Subject: BODY CONTROL MODULE (BCM) CONFIGURATION	Service Alert No.: SA-060/20
	Last Issued: 08/03/2020

2019-2020 Mazda3
2020 CX-30

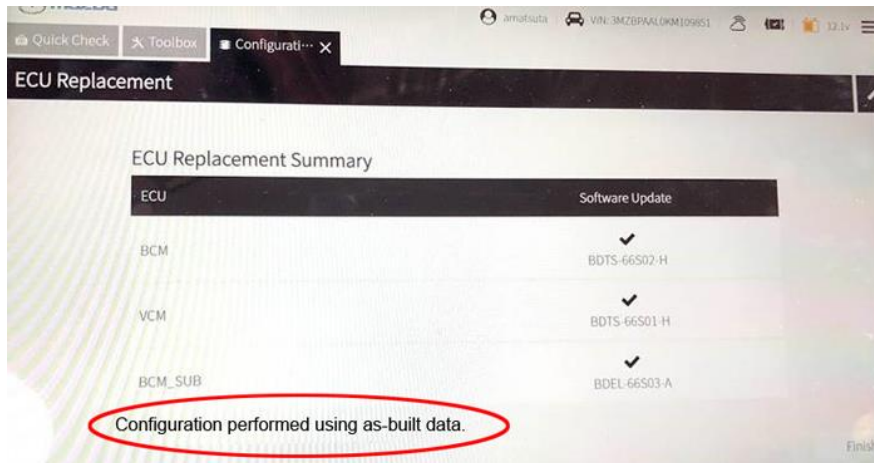
2. Open the front doors on both sides and the trunk (4SDN) / Lift gate (5HB) and keep them open until the BCM removal/installation procedure is completed.

NOTE: The ESU and Door-ESU synchronization needs to be performed when the BCM is replaced. It is performed automatically at the timing of first ignition ON, and to complete the synchronization process successfully, the front doors and trunk lid/lift gate need to be opened.
